STAFF REPORT
COMMUNITY DEVELOPMENT DEPARTMENT

SUBJECT: FP-2022-0027
Alamar Subdivision FP

Final Plat request for Phase 1 development to include 17 single-family detached building lots, 10 single-family attached building lots, and 4 common lots on approximately 3.71 acres of land in the TN-R zoning district, by Jeff Wrede, Noble Rock Development Inc.

B. Final Plat (date: 8/5/2022)

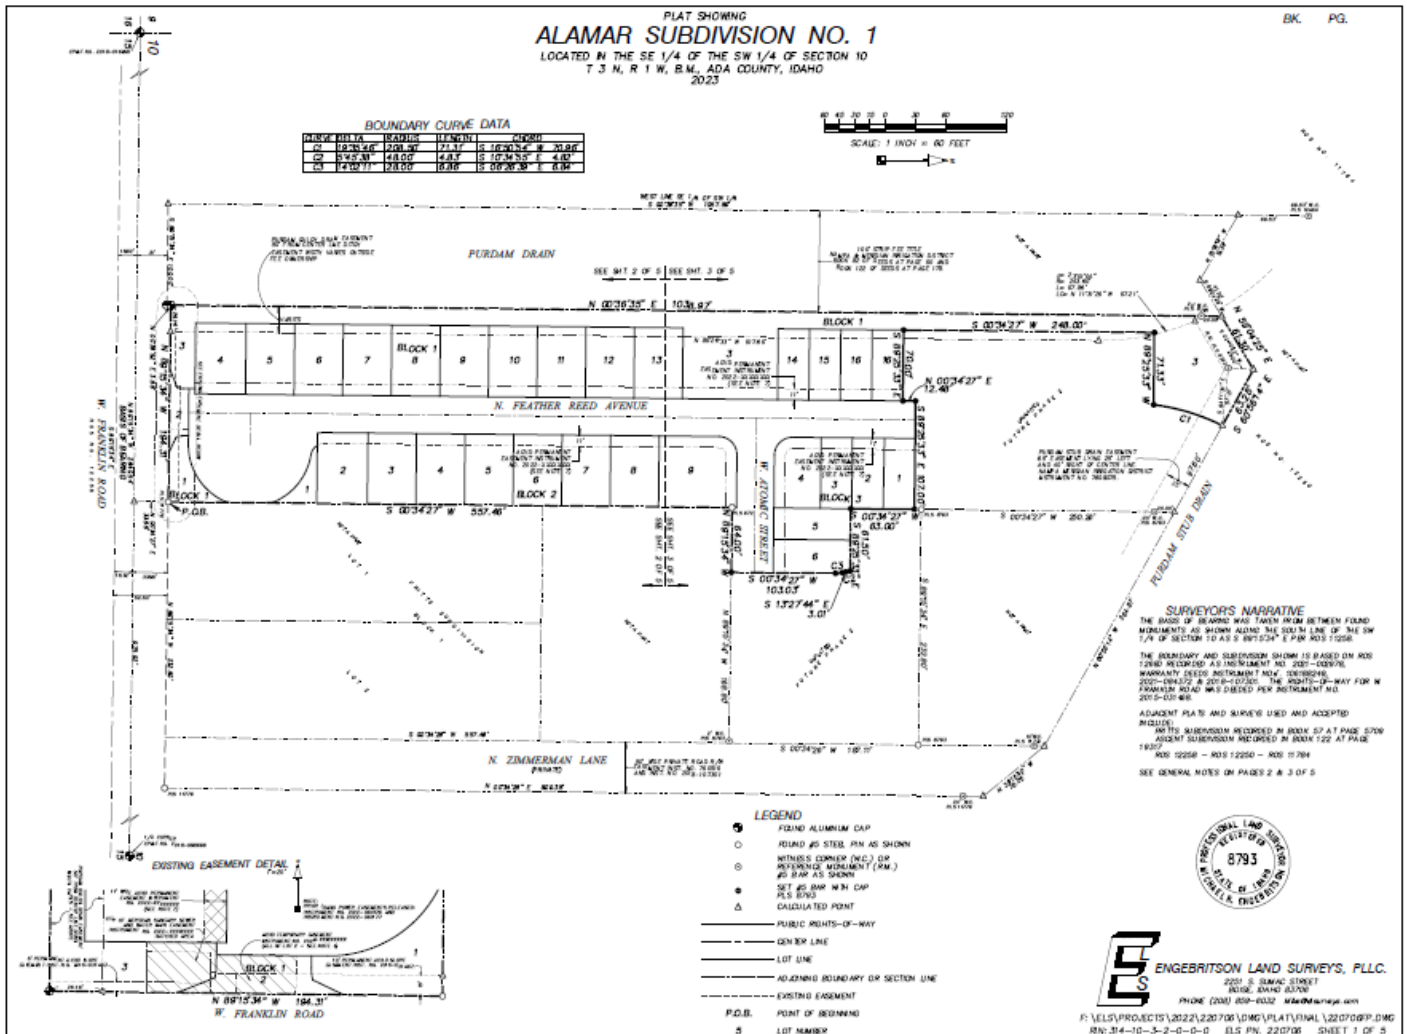
5. The final plat shown in Section V.B, prepared by Engerbritson Land Surveys, stamped on 8/5/22 by Michael R. Engerbritson, is approved with the following conditions to be completed at the time of Final Plat Signature:

- a. Revise plat note #11 referencing the Development Agreement to start with: "The Lots in this subdivision are subject to provisions contained within...";

- b. Plat note #6: add recorded instrument number.
 - c. Plat note #7: add recorded instrument number.
 - d. Plat note #12: add recorded instrument number.
